WG Adequacy #8

17 June 2022

Calibration 27-28 : Consultation report

Feedback public consultation – Renewable

Small scale battery capacity out of market

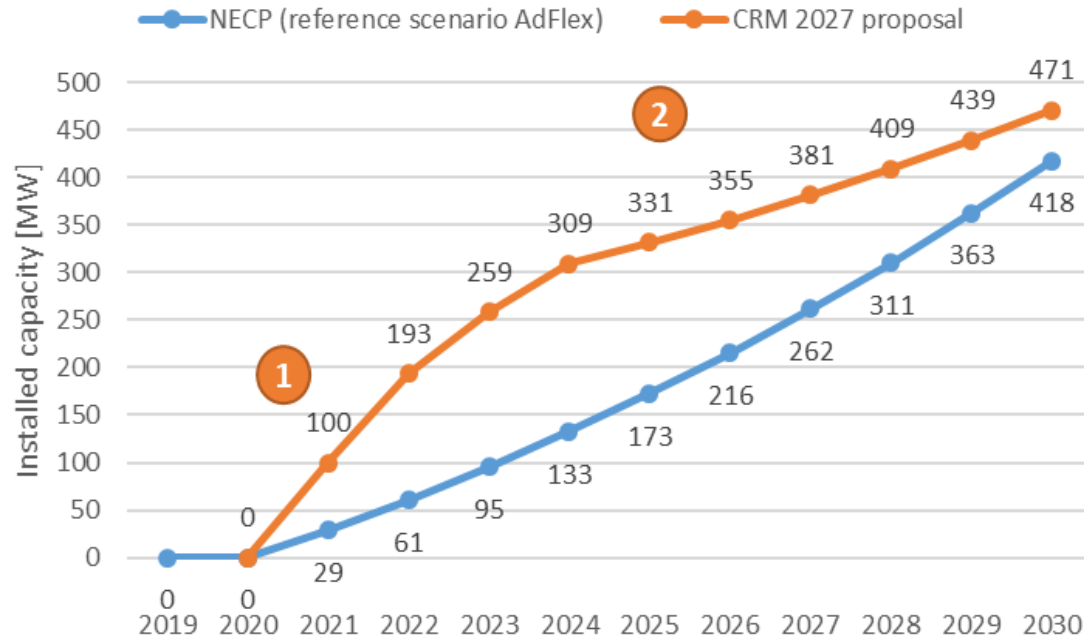
- Thinks the assumptions of Elia are overestimated and not based on factual market evolutions.
- Thinks for **small & large scale storage** the market depth is not enough and the market conditions and regulatory framework are too uncertain.
- Thinks for **V2G**, the technological conditions will not be met and the added value for customers will not be sufficient.

- No methodology for volume determination provided.
- No explanation of the proposed growth paths for installed capacity per battery type given.

- For **large scale batteries** the same trajectory as in the Adequacy and Flexibility study is used. Current market conditions support this trajectory.
- For **small scale batteries** the trajectory has been shifted upwards due to observed higher installation rates in the recent past and better regulatory and market conditions. Additional information provided on next slide.
- For **V2G**, Elia agrees that the proposed value might be too high and therefore proposes to keep the value of the 2026 auction, being **129 MW instead of the initially proposed 242 MW**, in order to be take into account some delay in the current development of the technology.

- 1 Observed higher installation rates due to high electricity prices and subsidies expected to last until 2024
- 2 Slower growth expected after 2024

Overview of proposed prices in € 2020/ MWh

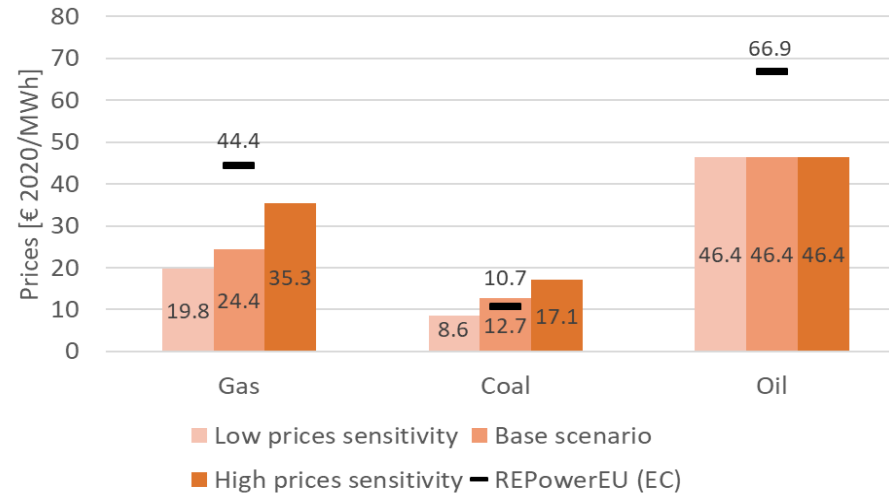
- Proposes to base the determination of fuel prices on those of LNG.

- Disagrees with the proposed prices as they are based on outdated WEO 2021 data and thinks the proposed prices are too low.
- Disagrees with the use of inflation for the calculation of energy prices and the applied inflation rates.

- Elia agrees that the WEO 2021 prices are outdated and thanks Febeg for the concrete proposal.
- Based on feedback from the previous task force, Elia looked for additional sources and **proposes an additional price sensitivity based on a recent European Commission document** on fuel prices trajectories between 2020 and 2050 for gas, oil and coal.
- Elia proposes to keep the same prices for CO2
- The inflation rates will be updated based on the latest data from the Federal Planning Bureau and are only used to reflect prices in €2020
